ISC Requirements and Conceptual Design Review Presentation

April 9, 2008
G080255-00

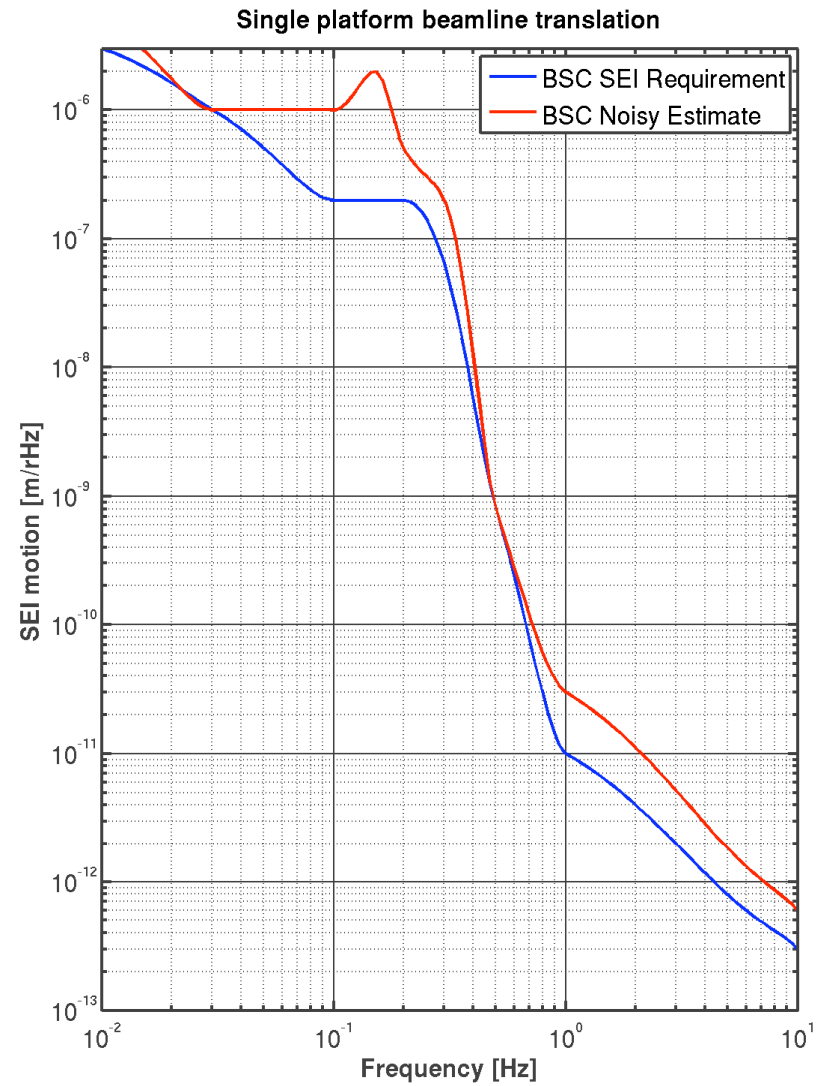
B, cont'd. Is mode 0 a stepping stone before including a SRM? How much of future ISC time will be used for developing some of these modes? Is it possible to go forward and concentrate on a single mode of operation?

- Mode 0: depends what is meant by stepping stone ...
 - Might very well want to make a science run in this mode
 - Still need to analyze controls for this mode; may want to increase asymmetry, e.g.

Test mass alignment control through M2 with radiation pressure

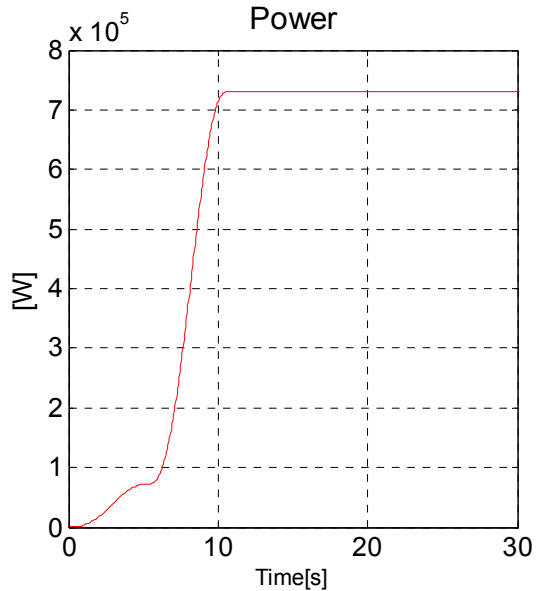
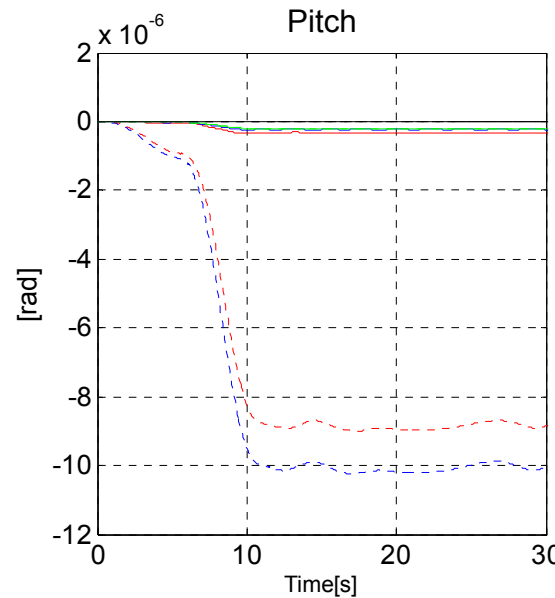
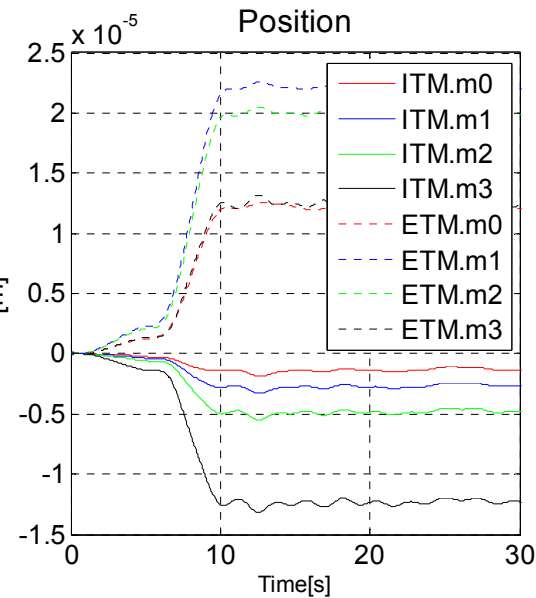
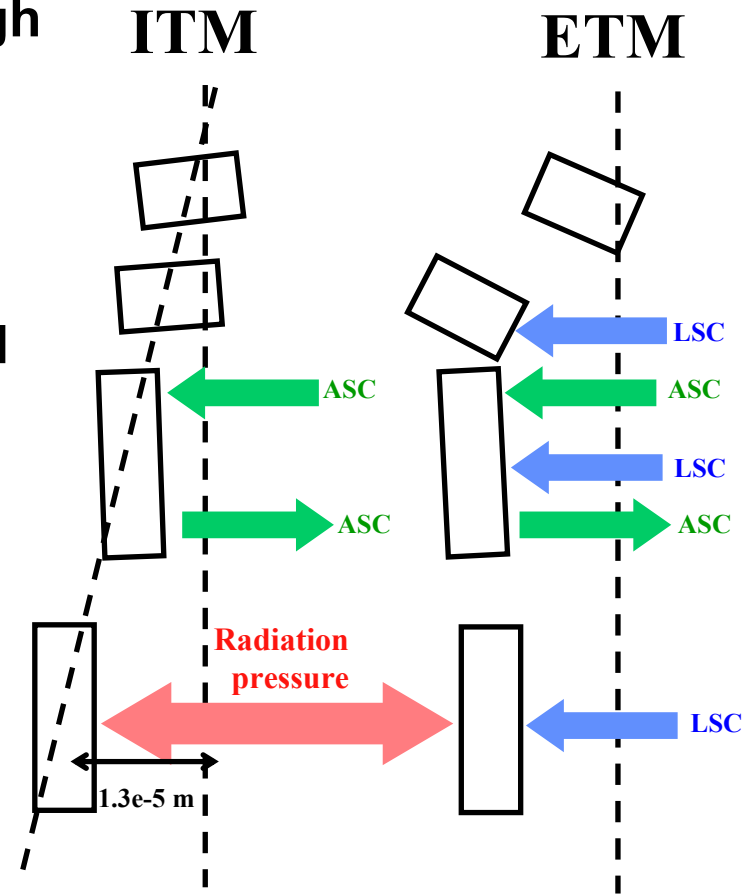
Is there enough force to deal with radiation pressure---both longitudinal and due to the Sidles-Sigg angular instability?

In particular during times of heightened seismic activity which presumably leads larger than usual power and angle fluctuations. What is the headroom to deal with non-stationary environmental disturbances?

- Longitudinal:
 - static force is compensated at the Top Mass: ~10 microns out of 100 micron range
- Angles:
 - Osamu Miyakawa did some E2E modeling of an arm cavity at full power
 - Let's look at some of his results, from G060396-00 ...

- Control M3 through M2
- f^3 filter
- Boost at 2Hz
- 10Hz control band width
